# UNITED STATES PATENT AND TRADEMARK OFFICE

APPLICATION NO.	FILING DATE	FIRST NAMED INVENTOR	ATTORNEY DOCKET NO.	CONFIRMATION NO.
10/812,359	03/30/2004	Youichi Zenda	001309.00060	4112

**Office Action Summary**

## **DETAILED ACTION**

**Figure 1, Annotated  
From Rapp (4,659,237)**

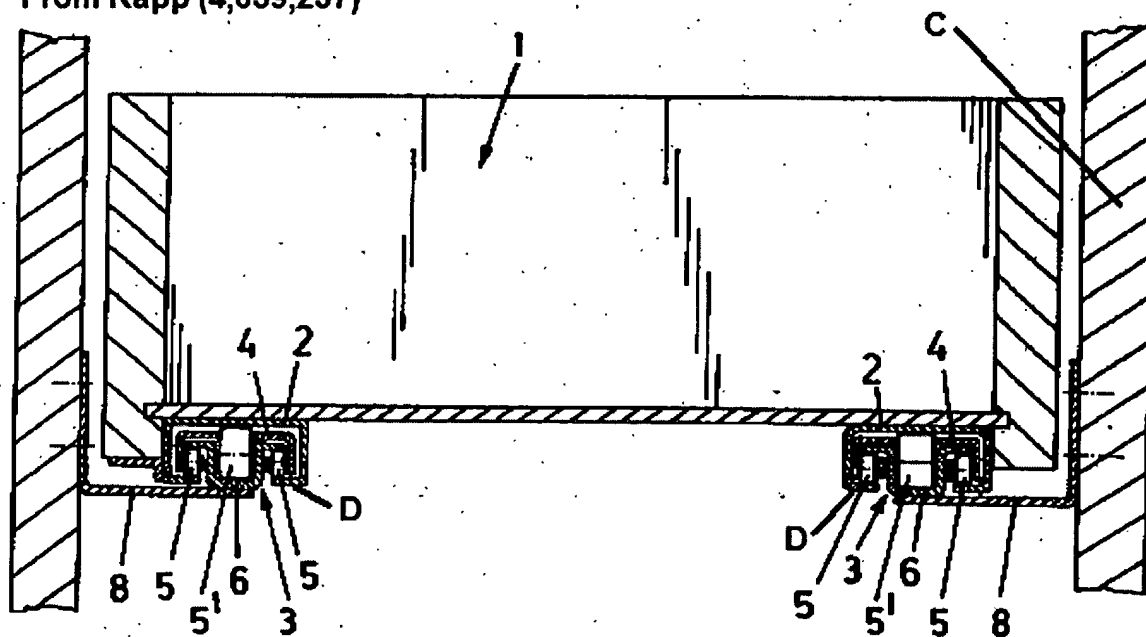
57. Regarding claim 1, Rapp teaches a structure wherein at least a rear end side of an object (1) is supported in a box body (Item C in Figure 1 Annotated) in a manner movable along back and forth and a front end side thereof is supported in a manner movable along back and forth by a floor (6) at least through a rolling supporting body (5') so as to draw the object forward from a stored position in the box body (C), and characterized by that the rolling supporting body adopts

a free motion rotating body (5') whose upper end makes an abutting contact with a downward facing surface (2) of the object (1) and whose bottom end contacts the floor (6), and the free motion rotating body (5') supports the front end side of the object with making a rolling movement at a half traveling speed of the object. The examiner points out that, due to basic physics, the free motion rotating body (5') will inherently move at a half traveling speed of the object (1) when said object is moved horizontally.

58. Regarding claim 3, Rapp teaches a structure wherein the free motion rotating body (5') contacts the downward facing surface (2) of the object (1) and the floor (6) through an endless track (i.e., the outer surface of Item 5').

59. Regarding claim 4, Rapp teaches a structure wherein the free motion rotating body (5') is supported by the object (1) in a manner capable of being suspended through a rail (Item D in Figure 1 Annotated) and a rotor (5).

60. Regarding claim 6, Rapp teaches a structure wherein the free motion rotating body (5') is supported by the object (1) in a manner capable of being suspended through a rail (Item D in Figure 1 Annotated) and a rotor (5).

61. Claims 14 and 15, as best understood, are rejected under 35 U.S.C. 102(b) as anticipated by or, in the alternative, under 35 U.S.C. 103(a) as obvious over Rapp (4,659,237). Rapp teaches the structure substantially as claimed, including a drawer (1) arranged at the lowest part of the box body (Item C in Figure 1 Annotated), said box body being a drawer storage portion.

Figure 3, Annotated  
From Onomoto (5,046,790)

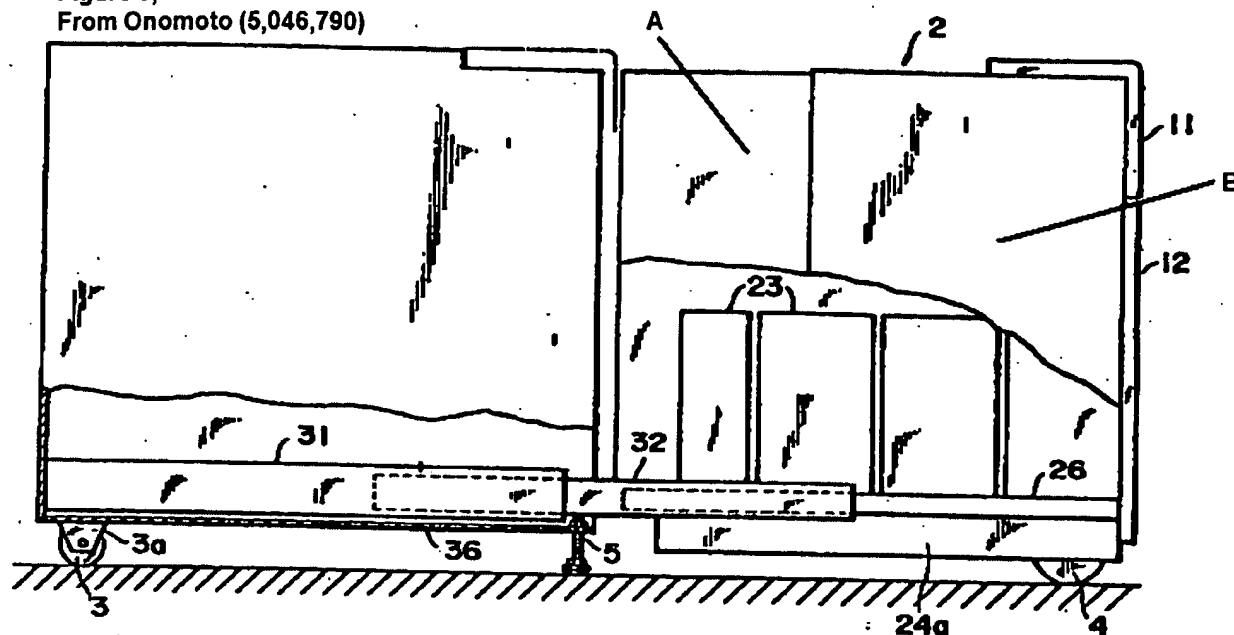
62. Claims 1, 3, 4, 6, 14, and 15, as best understood, can be alternately rejected, along with claims 16 and 17, as best understood, under 35 U.S.C. 103(a) as being unpatentable over Onomoto (5,046,790) in view of Reaney (5,779,067). Onomoto teaches the structure substantially as claimed, including a structure wherein at least a rear end side (Item A in Figure 3 Annotated) of an object (2) is supported in a box body (1) in a manner movable along back and forth and a front end side thereof is supported in a manner (Items 26 and 31-34) movable along back and forth by a floor at least through a rolling supporting body (4) so as to draw the object (2) forward from a stored position (see Figure 2) in the box body (1), and characterized in that the rolling supporting body includes a free motion rotating body (4) whose bottom end contacts the floor (see Figures 2-5), said free motion rotating body supporting the front end side (Item B in Figure 3 Annotated) of the object (2); said free motion rotating body being supported by the object in a manner capable of being suspended through a rail (31) and a rotor (33); wherein the object (2) is a drawer (see Figure 3) and the box body (1) is a drawer storage portion of a wagon equipped with a drawer (see Figures 1-3); and wherein the drawer (2) is arranged at the lowest part of the drawer storage portion (1).

63. The only difference between Onomoto and the invention as claimed is that Onomoto fails to teach a structure comprising a free-motion rotating body whose upper end that makes an abutting contact with a downward facing surface of the object, and that makes a rolling movement at a half traveling speed of the object; said free motion rotating body contacting the downward facing surface of the object and the floor through an endless track; and wherein the drawer has an arrangement in which each upper part of three sides of a bottom wall is surrounded by a standing wall and an upper part of one side thereof that is orthogonal to a direction accessible to an article to be stored is open.

**Figure 2, Annotated  
From Shapleigh (3,613,566)**

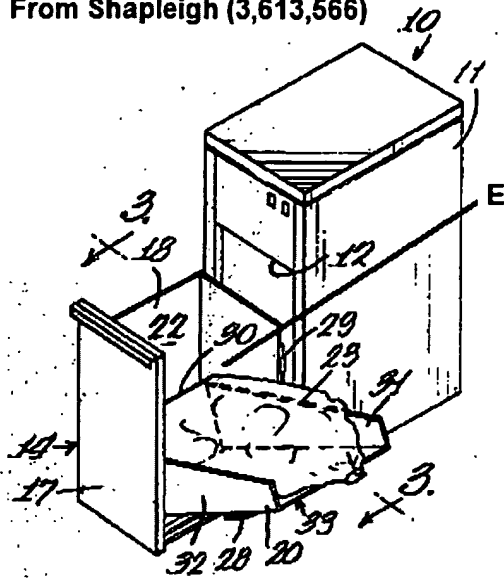
71. Claims 16 and 17, as best understood, can be alternately rejected under 35 U.S.C. 103(a) as being unpatentable over Rapp (4,659,237) in view of Shapleigh (3,613,566). Rapp teaches the structure substantially as claimed, including a drawer (1) arranged at the lowest part of the drawer storage portion (Item C in Figure 1 Annotated); the only difference being, Rapp fails to teach a drawer that has an arrangement in which each upper part of three sides of a bottom wall is surrounded by a standing wall and an upper part of one side thereof that is orthogonal to a direction accessible to an article to be stored is open. Shapleigh, however, teaches a drawer (22) that has an arrangement in which each upper part of three sides of a bottom wall (21) is surrounded by a standing wall (17, 18, 19) and an upper part of one side (Item E in Figure 2 Annotated) thereof that is orthogonal to a direction accessible to an article to be stored is open. It would have been obvious to one of ordinary skill in the art to replace the drawer in the structure of Rapp with the drawer taught by Shapleigh in order to provide easier access to the objects contained within said drawer, thereby providing the structure substantially as claimed.
